SERVICE INSTRUCTION

SI 06-01

SUBJECT: **AD 79-22-04, Alternate Means of Compliance**

MODEL/SERIALS AFFECTED:	AA-5	All
	AA-5A	All
	AA-5B	All
	AG-5B	Not Affected

CONTOUR INSPECTION TEMPLATE
Figure 1

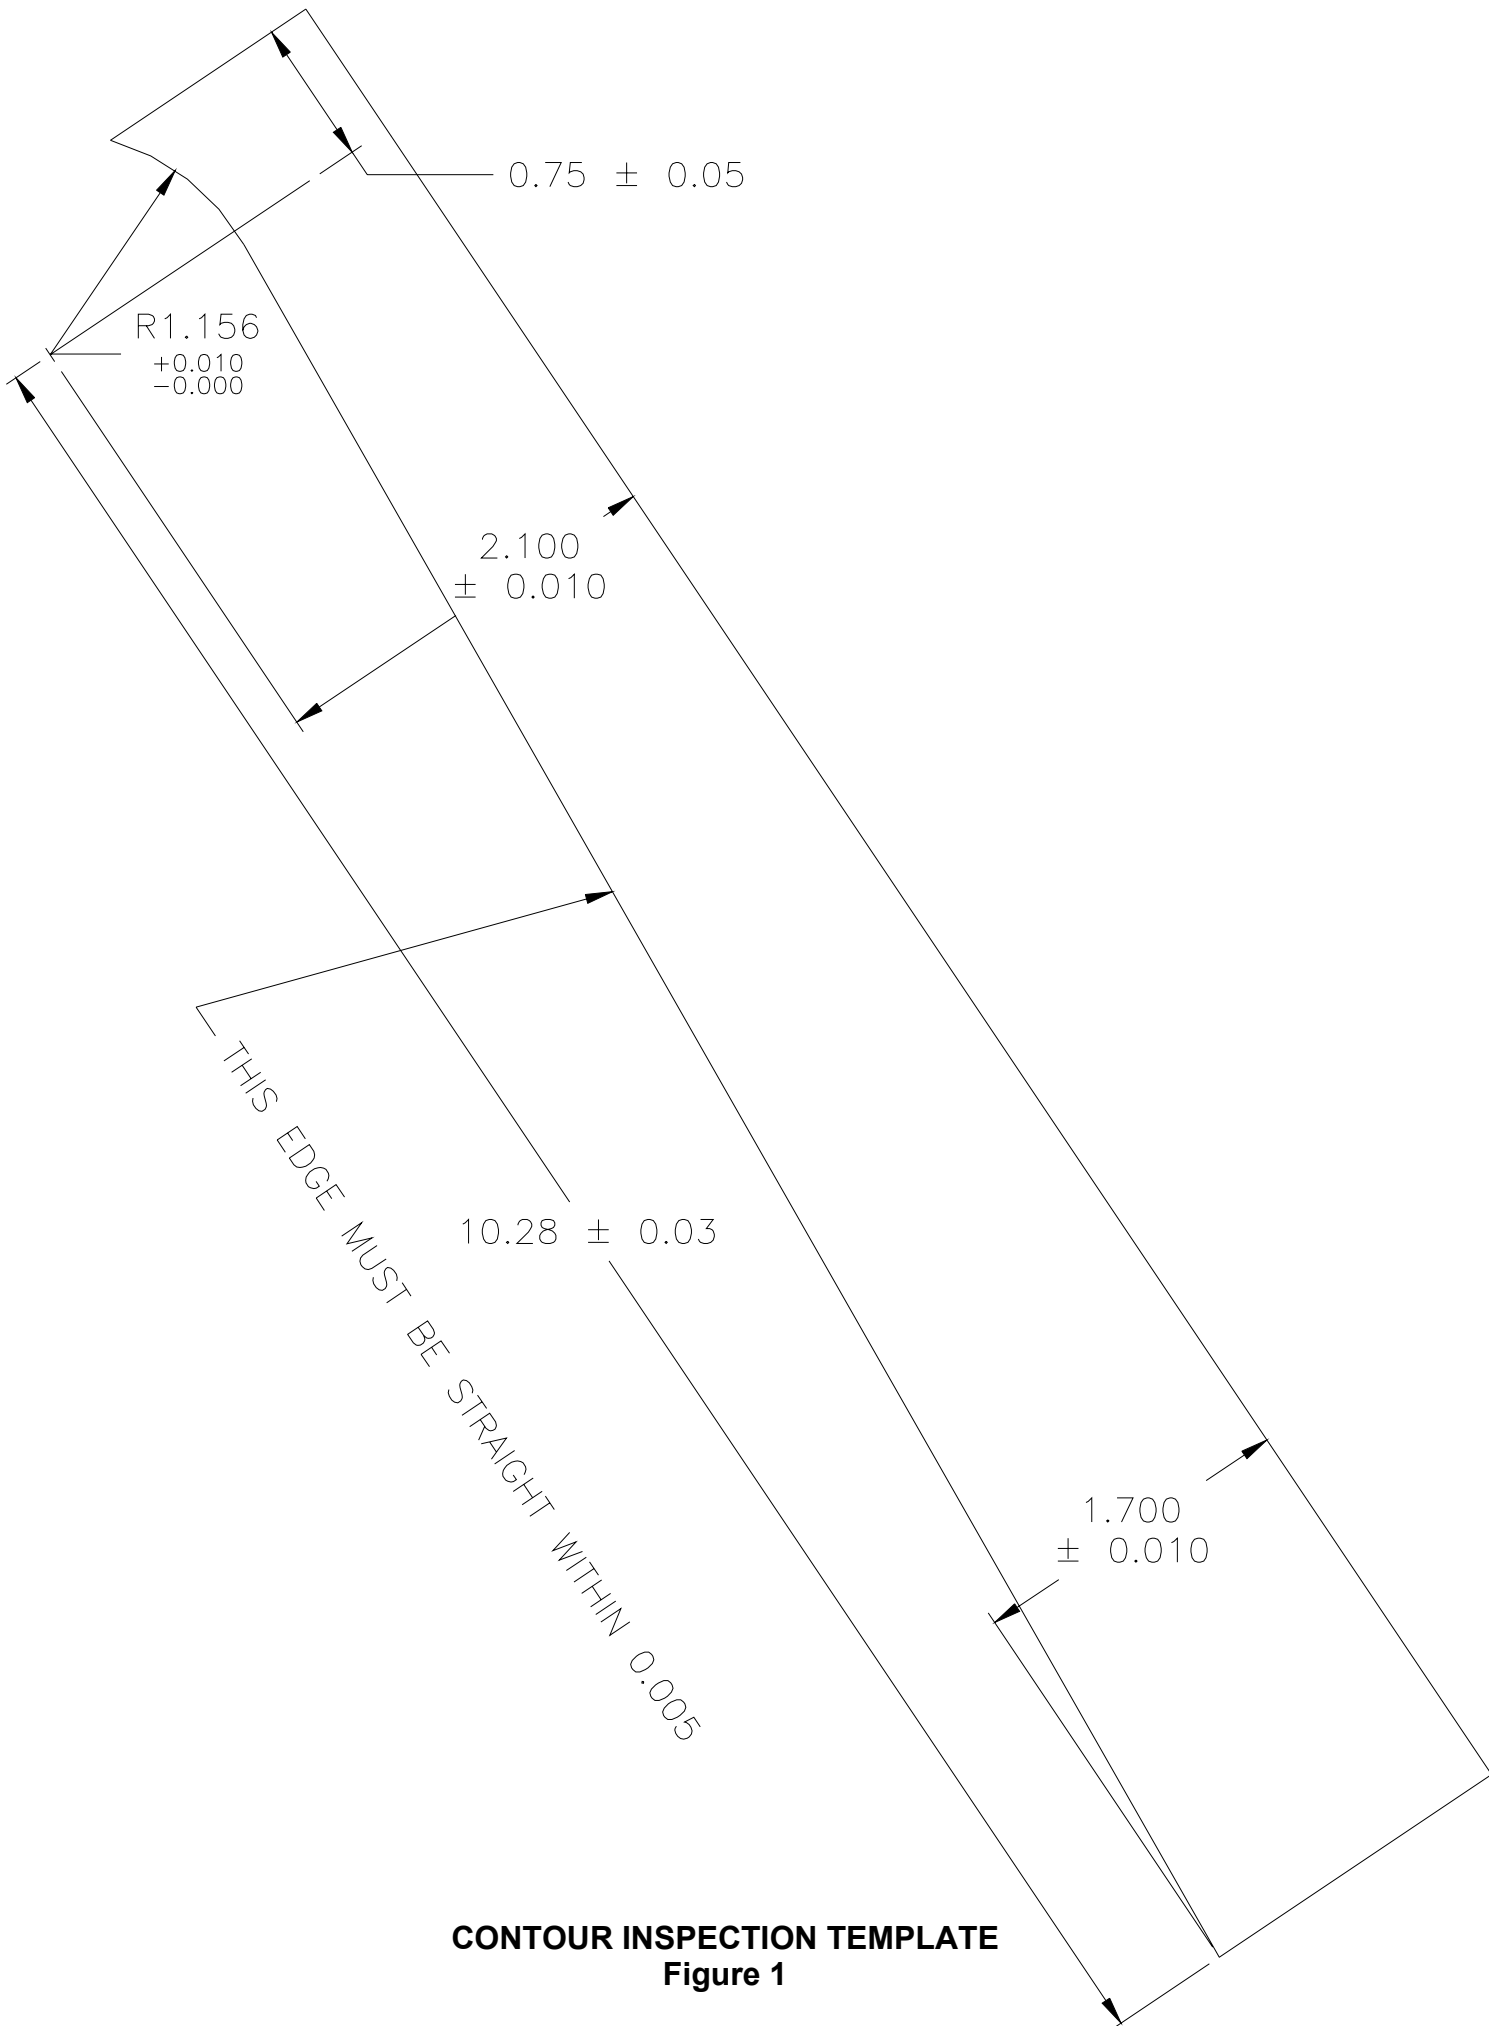
1. Fabricate the inspection template in accordance with Figure 1. The template should be made from at least 0.032-thick aluminum.
2. Locate the aircraft in a well lighted area for adequate inspection.
3. Using a ruler and a removable marker, place a mark at each 1 inch of aileron span at the leading edge and trailing edge on both upper and lower surfaces of each aileron.
4. Place the template across the aileron, perpendicular to the trailing edge at the first 1 inch mark as shown in Figure 2. Visually inspect the aileron skin between the forward and rear spar of the aileron for contact with the template at any location other than at the forward and rear spar.

CORRECT CONTOUR
Figure 3

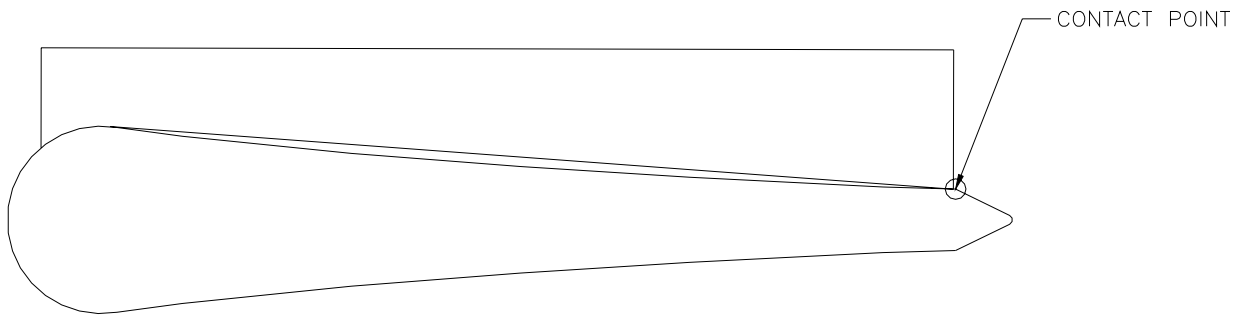
- C. If there is no skin contact with the template other than at the forward and rear aileron spar as shown in Figure 3, the aileron skin contour complies with the intended aileron design criteria. If both ailerons are found to be in contour and Service Bulletin 163 has been complied with, then the aircraft is acceptable and further repetitive inspections of the control system per Airworthiness Directive 79-22-04 are no longer required.
- D. If any aileron skin contacts the template at a point other than the forward and trailing edge spar as shown in Figure 4, the aileron is out of contour. Aircraft with an out of contour aileron must be inspected every 100 hours in service to the requirements described in AD 79-22-04 paragraph (b).
- E. Record compliance with this service instruction in the aircraft log book.
